Access Compliance Report Public Rights-of-Way (Curb Ramps)

ADA ID: RPAT220208134951 Ramp Type: Type 1 - Perpendicular Diagonal Initial Pass/Fail: Fail Overall Compliance: No Severity Score: 15

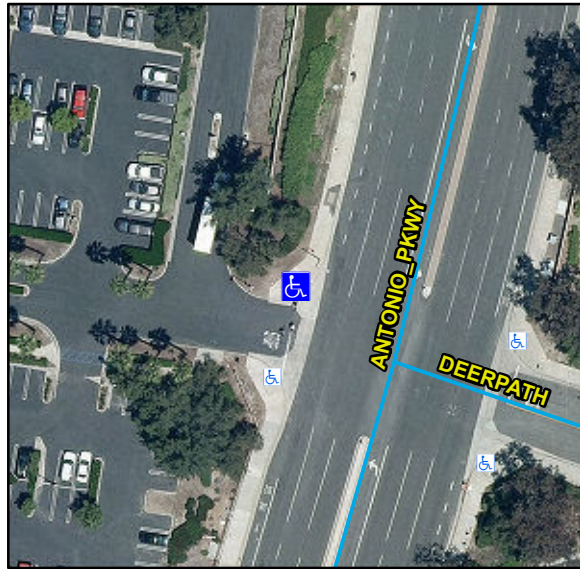
Compliance	Description	Data	Compliance	Description	Data
N/A	Ramp Length (in)	105	N/A	Flare Type LT	
Yes	Ramp Width (in)	52			N/A
Yes	Ramp Run Slope (%)	7.8	N/A	Flare Slope LT (%)	N/A
No	Ramp Cross Slope (%)	6.3	N/A	Flare Traversable LT	N/A
N/A	Landing Present	N/A	N/A	Flare Type RT	
N/A	Landing Length (in)	N/A			N/A
N/A	Landing Width (in)	N/A	N/A	Flare Slope RT (%)	N/A
N/A	Landing Run Slope (%)	N/A	N/A	Flare Traversable RT	N/A
N/A	Landing Cross Slope (%)	N/A	N/A	DWS Provided	N/A
N/A	Landing Movement Obstructed?	N/A	N/A	DWS Contrast	N/A
	Landing Movement Type	N/A	N/A	DWS Length (in)	N/A
N/A	Landing Shared	N/A	N/A	DWS Full Width	N/A
N/A	Clear Space	Yes	N/A	DWS Offset Left (in)	N/A
N/A	Clear Space To Crosswalk (in)	N/A	N/A	DWS Offset Right (in)	N/A
N/A	Marked Crosswalk 1	No	N/A	Marked Crosswalk 2	No
	Crossing 1 Direction	SW		Crossing 2 Direction	E
	Marked Crosswalk 1 Width (in)	N/A		Marked Crosswalk 2 Width (in)	N/A

N/A	Ramp Inside Crosswalk 1	N/A	Yes	Ramp Inside Crosswalk 2	N/A
	Crossing 1 Slope (%)	1.6		Crossing 2 Slope (%)	3.4
	Crossing 1 Cross Slope (%)	4.9		Crossing 2 Cross Slope (%)	6.3
N/A	Gutter Ponding	N/A	No	Curb Slope	11.6
No	Gutter Lip Height (in)	0.25		Road Run Slope (%)	8
N/A	Gutter Run Slope (%)	N/A		Road Cross Slope (%)	2
N/A	Gutter Cross Slope (%)	N/A			
Yes	Overall Surface Condition: Acceptable		No	Perp Joint Present	No
	Cross Gutter Present?	Yes		Spandrel Present?	Yes
	Replace Cross Gutter?	No		Replace Spandrel?	No

Remove & Replace Curb Ramp With Two New Directional Ramps or Equivalent.

R304.2.2, R204.3, R304.5.3, R302.7.2, STD 1115
